Our Ref: M220565

2 April 2024

**RESPONSE TO THE COUNCIL REQUEST FOR ADDITIONAL INFORMATION
260 Eighth Avenue, Austral (DA-381/2023)**

Figure 2 Council sketch plan from email dated 14 February 2024

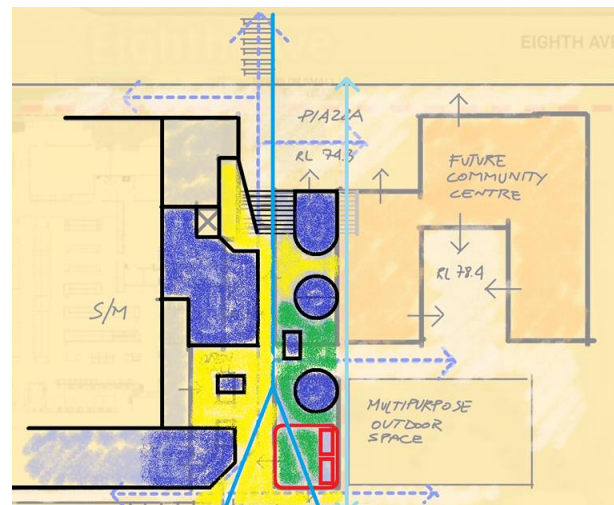
The proposal has been amended following collaboration and discussion with Council. Two online meetings have been held between the Applicant's Project Team and Council on 7 December 2023 and 5 February 2024 to discuss the various issues and proposed resolutions. During the meeting held on 5 February 2024, an in-principle agreement was reached with Council regarding the potential layout and design of the development, particularly as it relates to the location and design of the through-site link and public piazza (**Figure 1**). There has also been email and phone correspondence between the Applicant and Council to discuss the issues and potential changes to the development. Of particular relevance is the email received from Council, dated 14 February 2024, which included an additional sketch plan (**Figure 2**) deviating from the general arrangement as agreed on the 5 February 2024.

As demonstrated in the submitted architectural plans, the proposal has sought to provide a balance between the sketch plans emanating from both the online meeting and Council email. Whilst the development does not strictly apply the design elements of the Council email, the design intent of this sketch has been incorporated where practicable. Of most relevance, the amended proposal provides the following:

The abovementioned changes have balanced the suggestions made by Council whilst maintaining the delivery of a feasible development. This is achieved through the provision of a generously sized public piazza and transparent through-site link with appropriate connectivity to the neighbouring property. The design allows for ultimately flexibility for future development to the east, with three connection points between the centre and neighbouring property. It is prudent to note that a number of elements contained within the sketch plan issued in Council's email cannot be delivered due to adverse feasibility impacts, as follows:

- The circular tenancies create significant limitations to functionality, ability to lease and constructability. To satisfy the intent of Council, the amended proposal provides a considerable break between speciality tenancies with curved facades to encourage pedestrian circulation.
- The provision of multiple, smaller separated tenancies results in a significant increase in construction cost and inefficiency in design. The provision of two larger tenancies along the eastern boundary, which can be subdivided, will provide for a high level of articulation and activation as desired.
- The delivery of a food truck parking space is not appropriate for the typology of development or relationship to built form. To manage this space upon operation of the centre is not feasible, and can result in adverse safety, health and cleanliness impacts.
